**バングラデシュ国**  
**持続的な水関連インフラに係る能力向上プロジェクト**

**パイロットプロジェクト報告書**

2017年6月

JICA EXPERT TEAM

図-5 上流既設堤防取り付け部設計拡大図 (

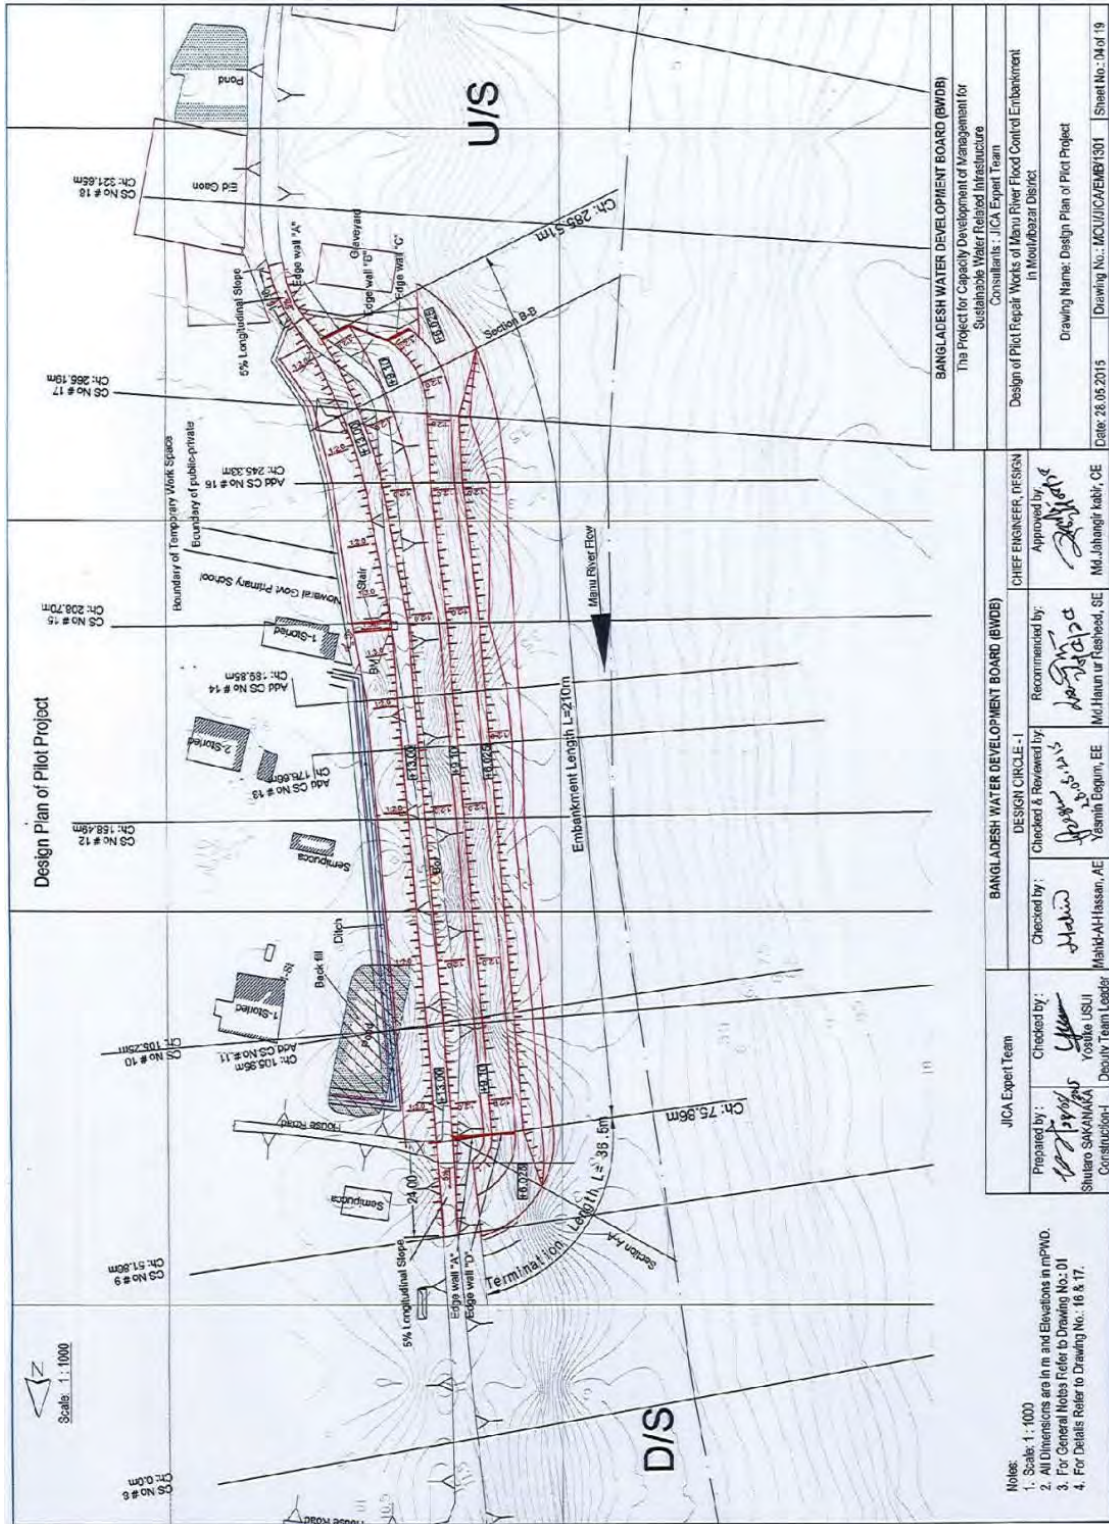
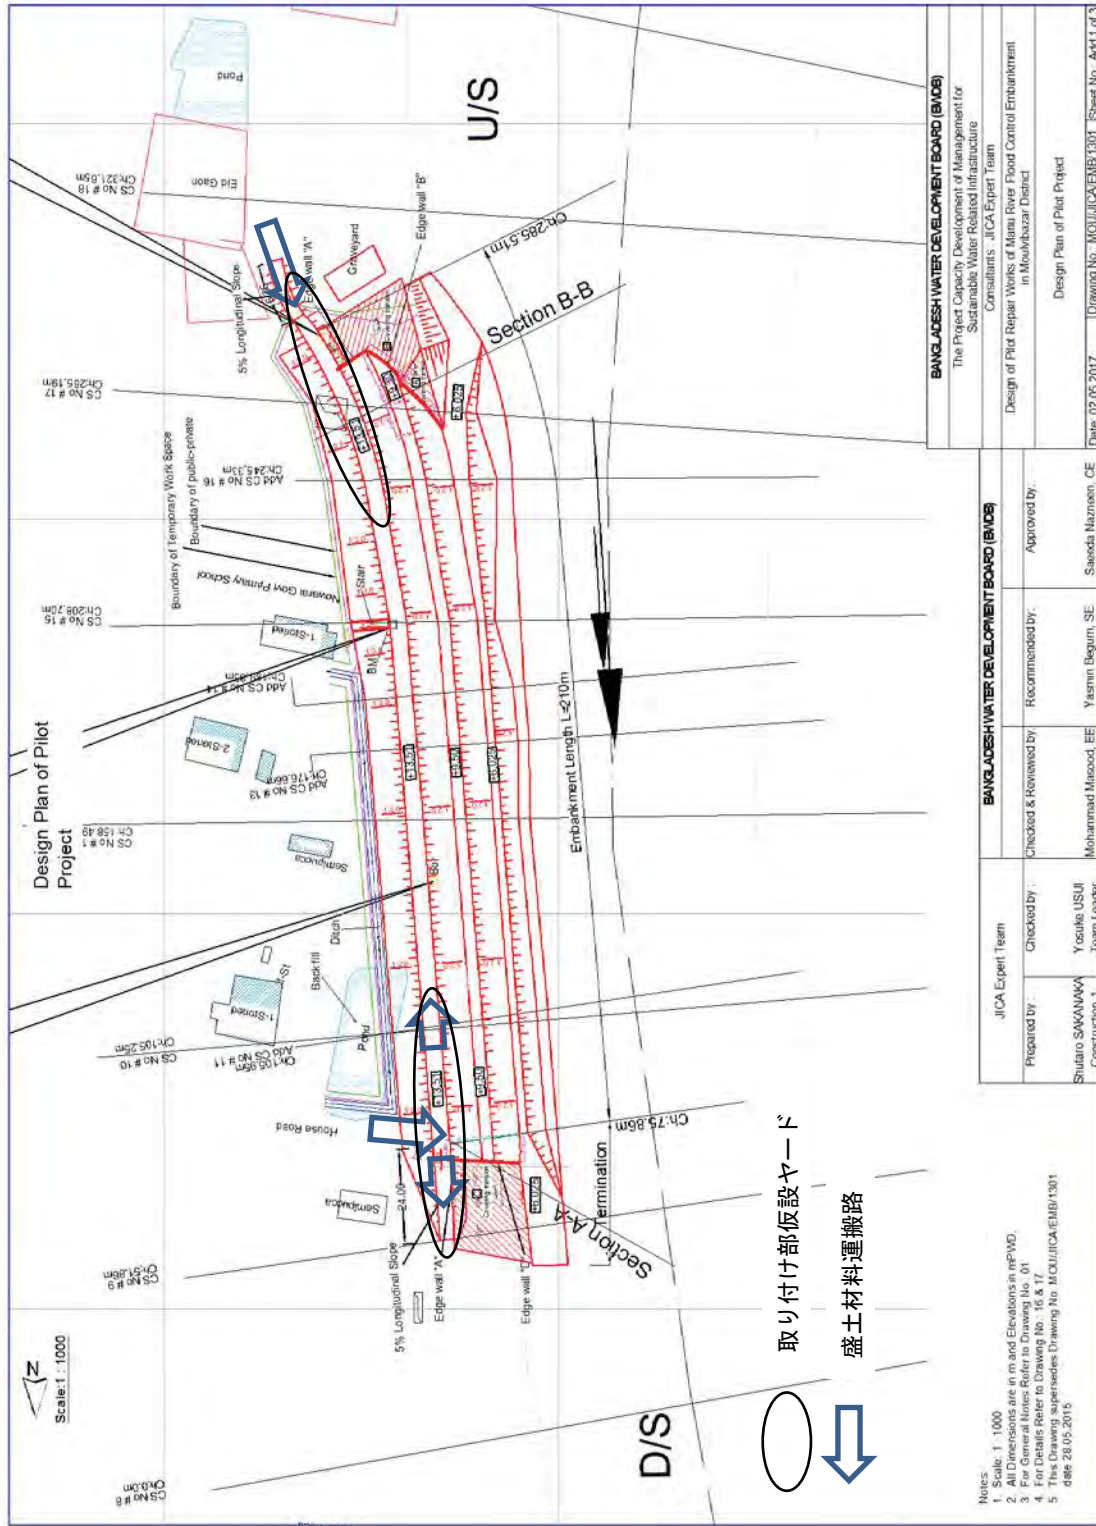
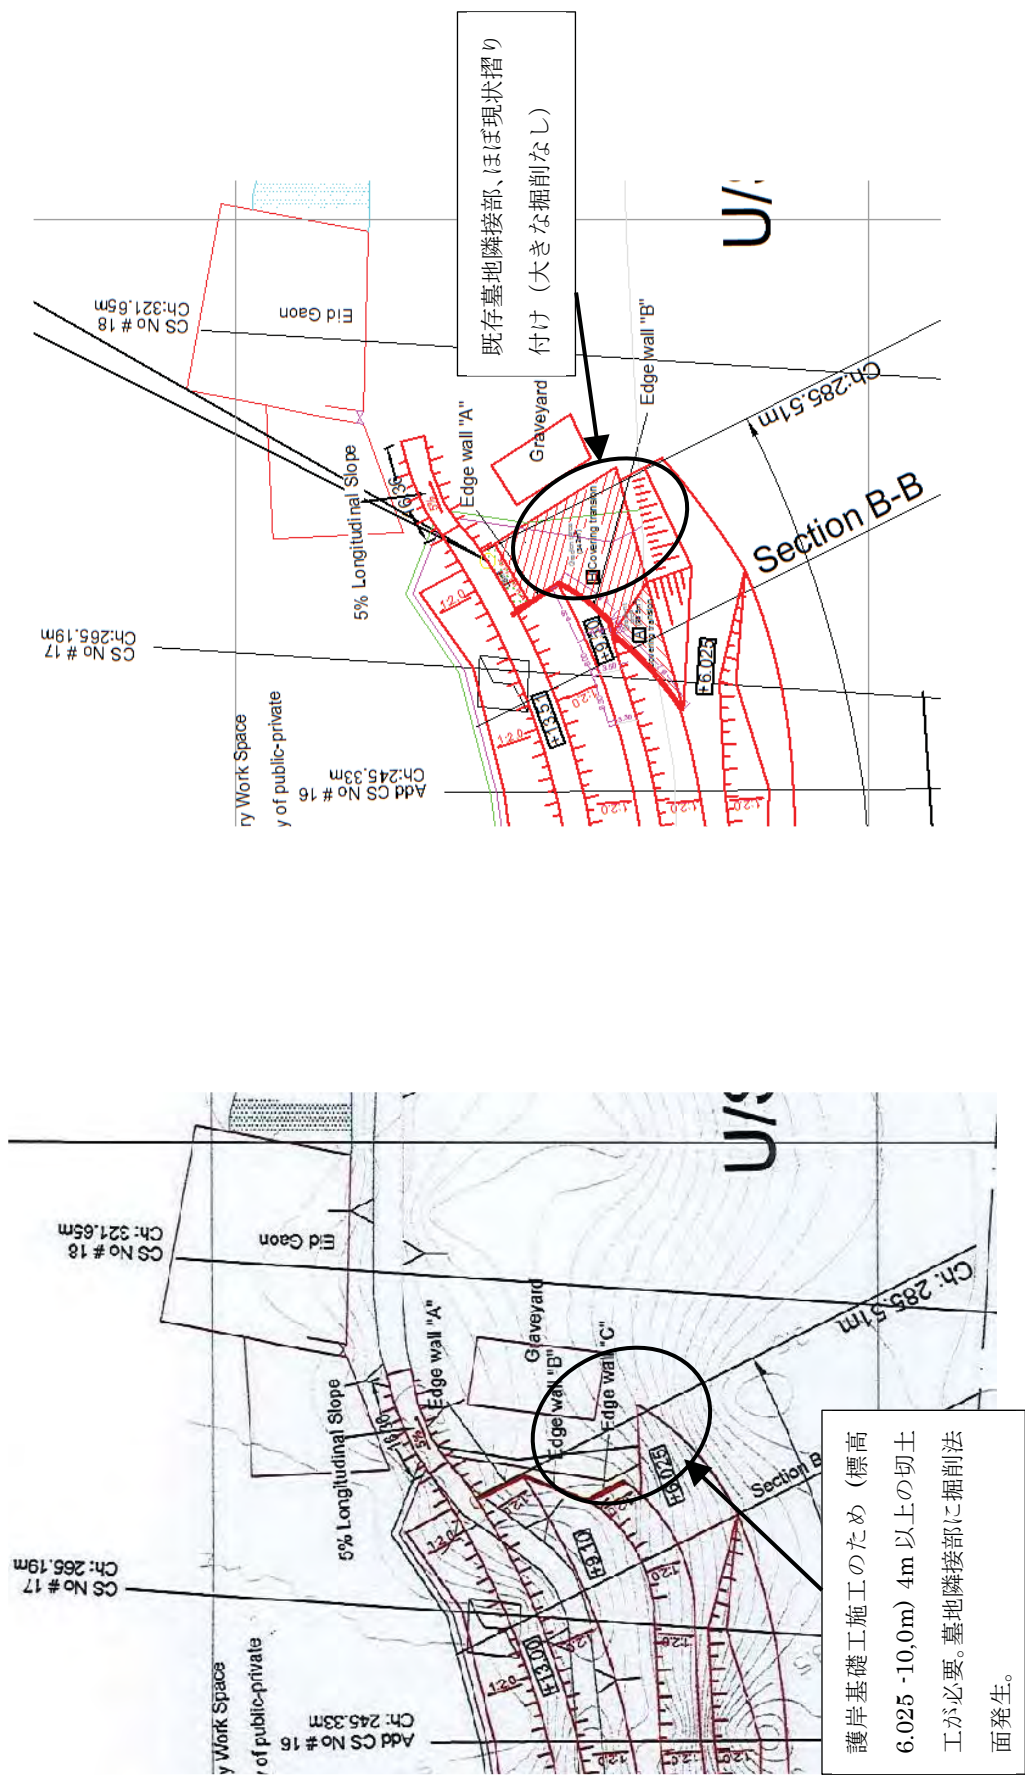
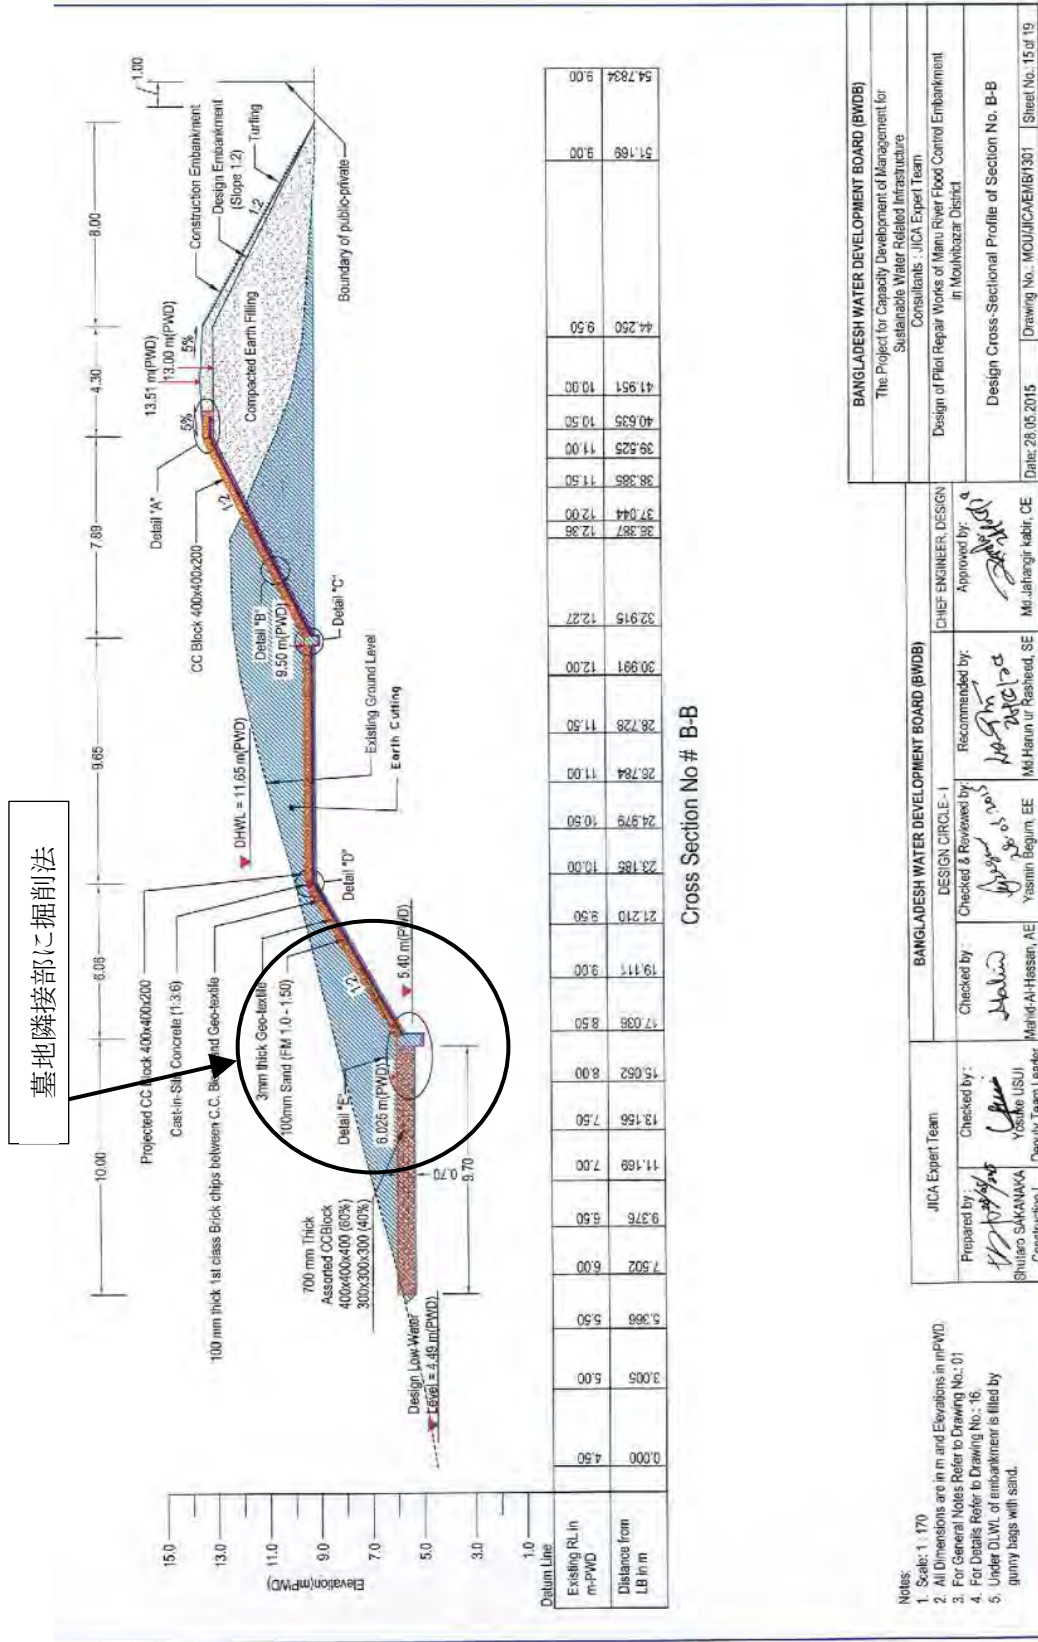
改修堤防上流部の既設堤防取り付け部は、隣接既存「墓地」地区間際まで掘削し、取り付け部を築造し、その後法面防護部を現場摺り付け盛土とする設計であった。地元住民より、この「墓地」隣接地の掘削に対する強い反対の要望が出され、現況地盤掘削をできるだけ少なくする方法の検討及び設計変更が生じた。度重なる現地調査・提案の後、2月26日に Dhaka にて設計担当者間で設計変更案について合意した、また、3月11日の設計担当者による現地確認後、変更した法面覆工が実施された。この際、法面覆工時に盛土運搬予定路を仮設作業ヤードとして使用したため、結果として堤内地側盛土工が4月にずれ込む結果となった。これらの設計変更検討・確認作業により、約14日間の遅れが生じた。

護岸基礎工施工のため（標高 6.025 -10.0m）4m 以上の切土工が必要。墓地隣接部に掘削法面発生。

既存墓地隣接部、ほぼ現状掘り付け（大きな掘削なし）

当初計画および変更後計画図面を、図-2～図-7に示すとともに、上流取り付け部の現地写真、BWDB設計局との議事録を付属資料に示す。

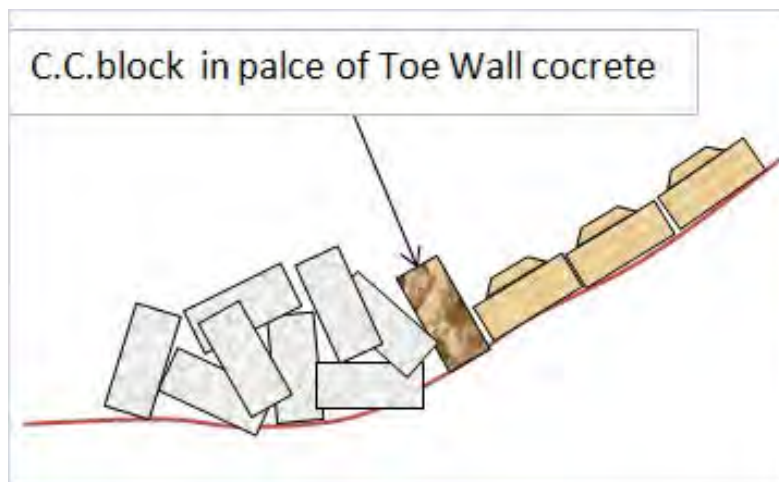
- 1) [A] zone can covered by placing of C.C.Blocks with projection (1:3:6mix) with filter material(Sand,Geo sheet, brick chips)
- 2) [B] zone should be covered by placing of C.C.Blocks with projection (1:3:6mix) with filter material(Sand,Geo sheet,brick cheaps)
- 3) [B] zone is area from the 6.025m (PWM) up to 11.65m(PWD) which is D.H.W.L.

If impossible by C.C.Blocks with projection, the zone between from 10.5m (PWD) up to 11.65m (PWD) can be placed by Plane blocks because of the budgetary restriction.

Furthermore, if impossible by Plane blocks such zone as above mentioned, turfing cover is acceptable.

- 4) The zone between from 11.65m (PWD; D.H.W.L) up to 13.10m (PWD; Crest Level) should be covered by turfing.
- 5) The zone below [A] zone and [B] zone should be filled with assorted C.C. Blocks (40×40×40 & 30×30×30)
